# PHIPPS PLAZA - HOTEL AND TOWER

SPI-12 DEVELOPMENT REVIEW COMMITTEE  
RESPONSE TO COMMITTEE RECOMMENDATIONS

SPI-12 Development Review Committee

1. 3:00 Proposed Development Address: Phipps Plaza Redevelopment

## DIAGRAM OF DESIGN IMPROVEMENTS

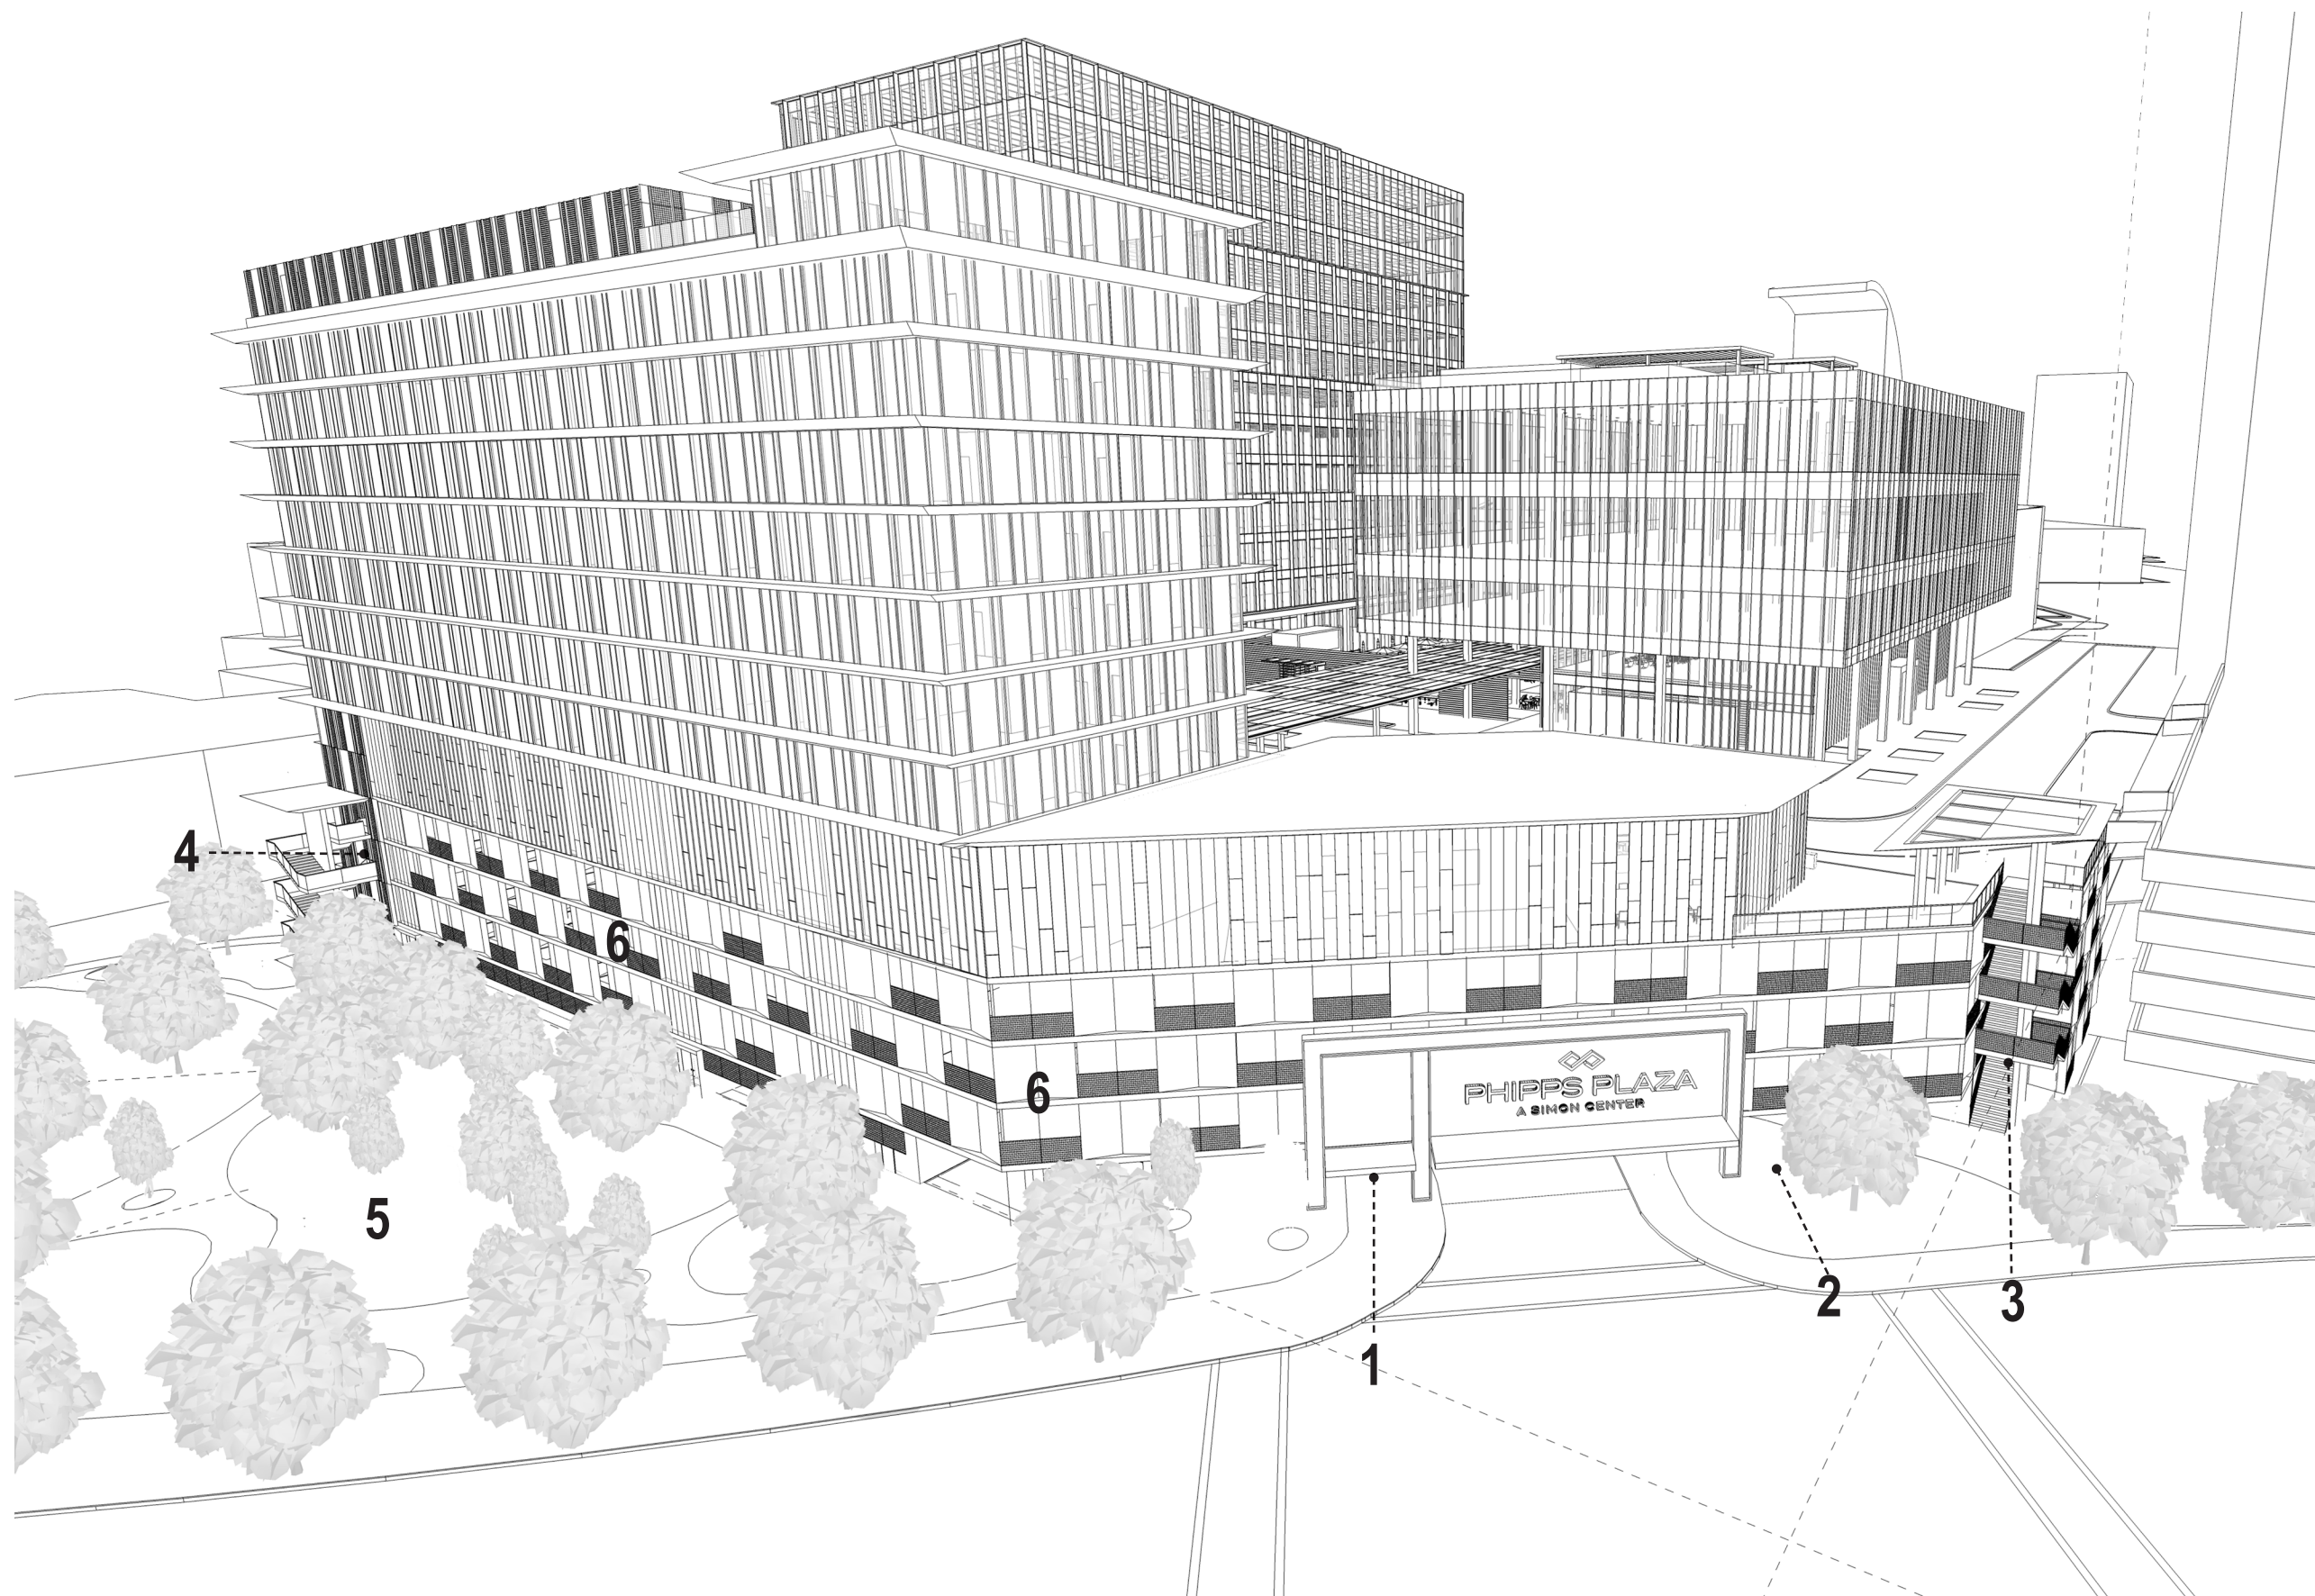
The committee expressed dissatisfaction with the design of the development – particularly with regard to the Phipps Boulevard façade and recommends the applicant focus on creating a more porous façade that engages the street rather than creating an unwelcoming fortress-like aesthetic. The committee recognized design restrictions including a 42’ grade difference and existing detention vault on the site, but does not feel that these are insurmountable. Suggestions for achieving this including creating some sort of grand stairway or progression of terraces in the proposed park space that invites pedestrians to engage with the development, is activated and hints at the uses available within the development at the plaza level.

1. Pedestrian entrance is visibly stronger and more inviting. Canopy, lighting, signage and enhanced paving mark the entrance.
2. Bicycle parking is visible and accessible to public.
3. Public stair has been repositioned for more visible connection to public entrance and connection along Phipps Boulevard to the future PATH400 and Lenox Road multiuse trail.
4. Additional public stair connects park to plaza level and engages the street activities.
5. Park design encourages engagement from the street, with paths, benches and open green space. Low berms help to mitigate the perceived scale of the facade.
6. Deck elevation is more open and has more variety of materials to reduce its perceived scale and create a more porous façade.

HOTEL AND PARKING - NORTH ELEVATION

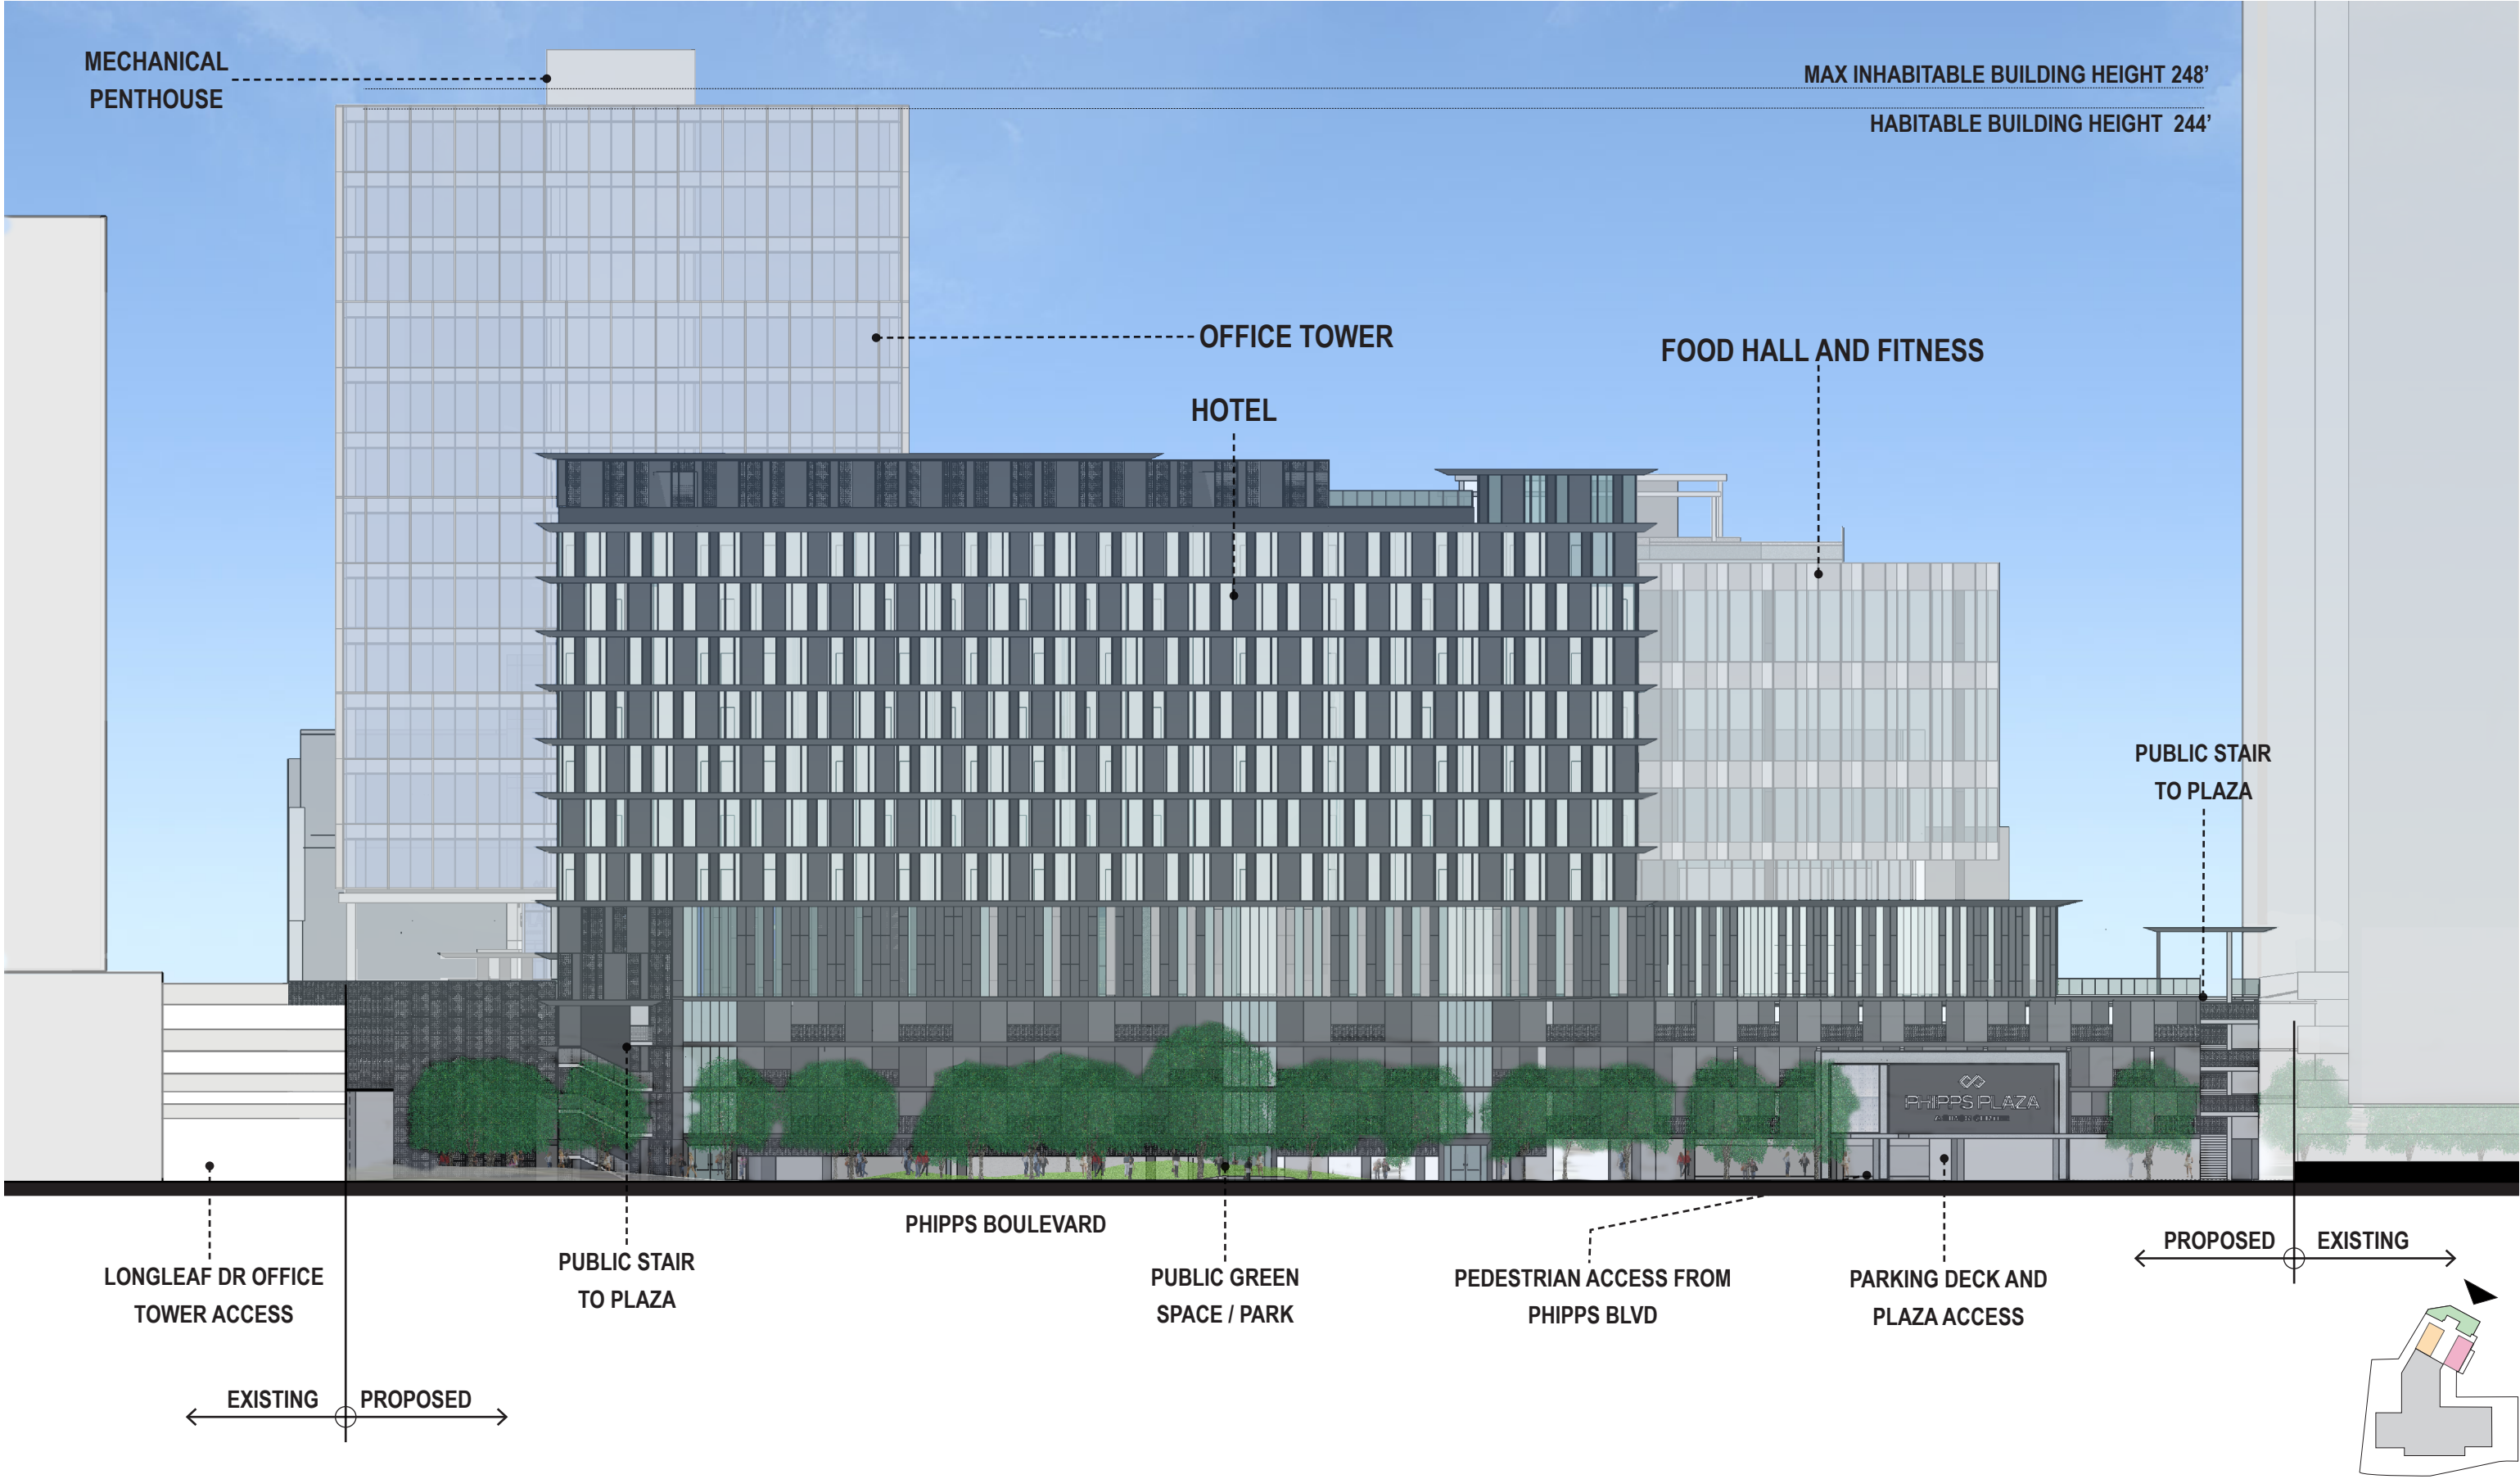
Recommendation: The committee commends the applicant for creating greenspace and is amenable to a variation regarding the supplemental zone along this frontage, however, does not feel that the proposed design achieves the intention of the district and recommends it be revisited to create a more porous façade that engages the street.

*Recommendation:* The committee is amenable to a variation regarding fenestration along this frontage, however, does not feel that the proposed design achieves the intention of the district and recommends it be revisited to create a more porous façade that engages the street.
